ULNRC-05518

**DOCKET NUMBER 50-483
CALLAWAY PLANT UNIT 1
UNION ELECTRIC CO.
FACILITY OPERATING LICENSE NPF-30
RESPONSE TO REQUEST FOR ADDITIONAL INFORMATION
REGARDING REPORT OF FIRST REPLACEMENT STEAM GENERATOR
TUBE IN-SERVICE INSPECTION (TAC NO. MD7372)
Reference: AmerenUE ULNRC-05450, Results of First Replacement Steam
Generator Tube In-Service Inspection, dated October 25, 2007**

**RESPONSE TO NRC RAI QUESTIONS/REQUESTS REGARDING THE
REPORT OF RESULTS OF CALLAWAY PLANT'S FIRST REPLACEMENT
STEAM GENERATOR TUBE IN-SERVICE INSPECTION**

TUBE SHEET NAMING CONVENTION

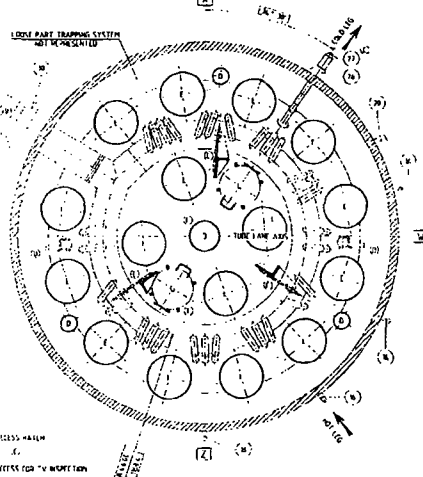
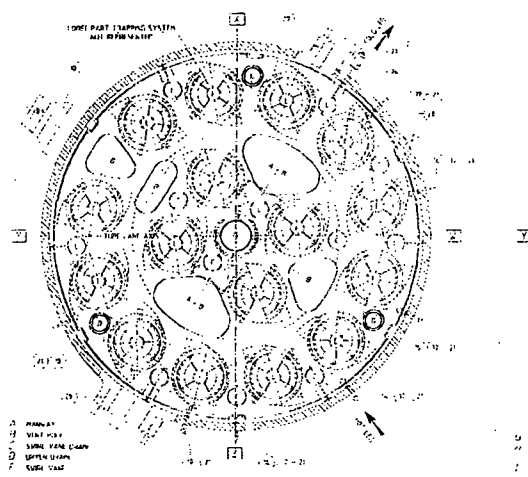
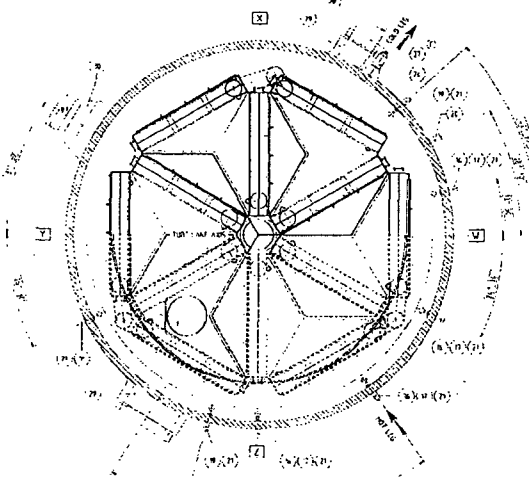
3. *For future reference, please provide the following information regarding the design of your replacement steam generators: the tubesheet thickness (with and without clad), the method used to expand the tubes into the tubesheet and the extent of expansion, the extent to which any tubes were stress relieved following bending, the radius of the smallest radius tubes, the tube support plate thickness (including the flow distribution baffle, if any), the anti-vibration bar cross section (e.g., rectangular) and the depth of penetration of the anti-vibration bars. In addition, please provide a tubesheet map, sketch of each steam generator showing the tube support naming convention, and clarify the number of tubes in the steam generators since you indicated that you performed a 100% inspection which was indicated to be 5536 tubes, (and other prior documentation from meetings with the Nuclear Regulatory Commission indicates that there are 5872 tubes per steam generator).*

See Letter Attachment 2 (representative of each steam generator).

TUBE SHEET MAP (COLD LEG)

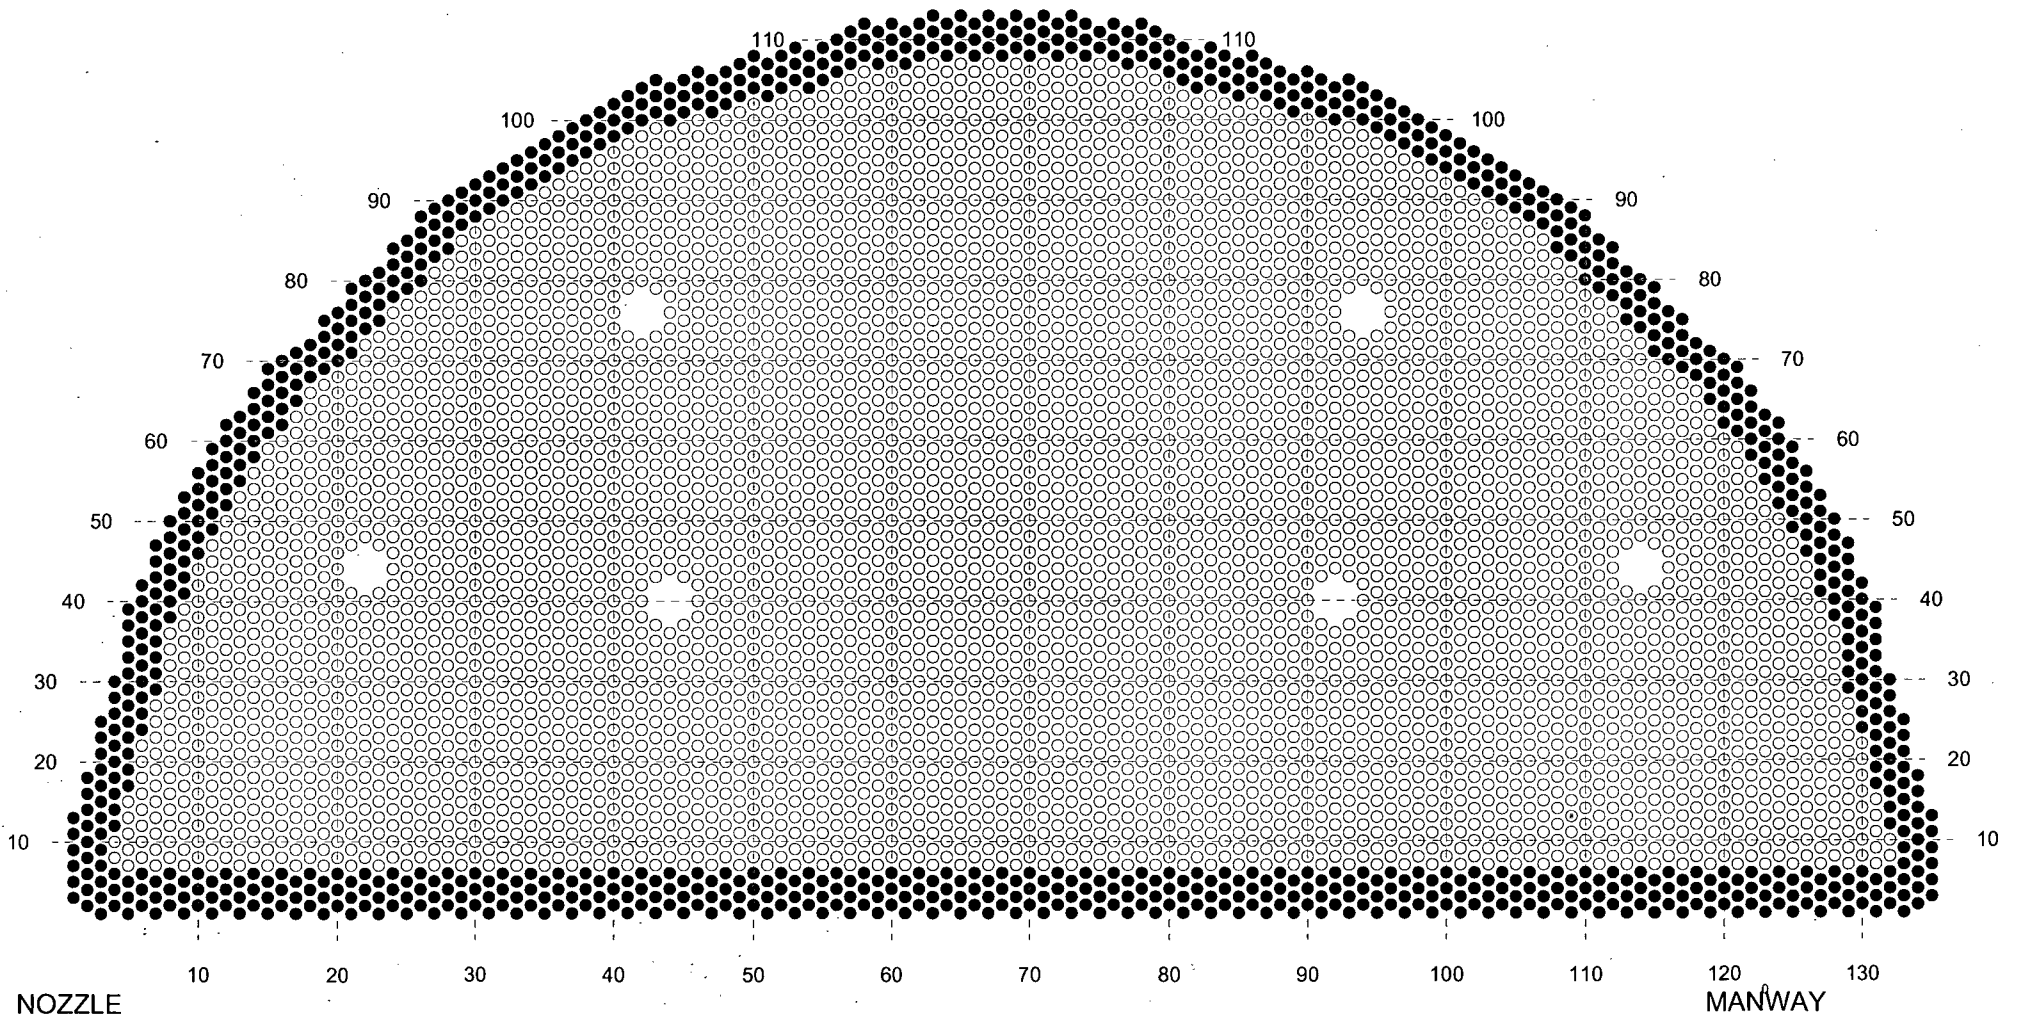
6. *Please clarify whether the +Point examinations performed in the periphery at the top of the tubesheet included both the hot- and cold-leg tubes.*

Periphery tubes in both the hot and cold leg tubes were inspected with the +Point. Refer to Letter Attachments 3 and 4 for more detail.
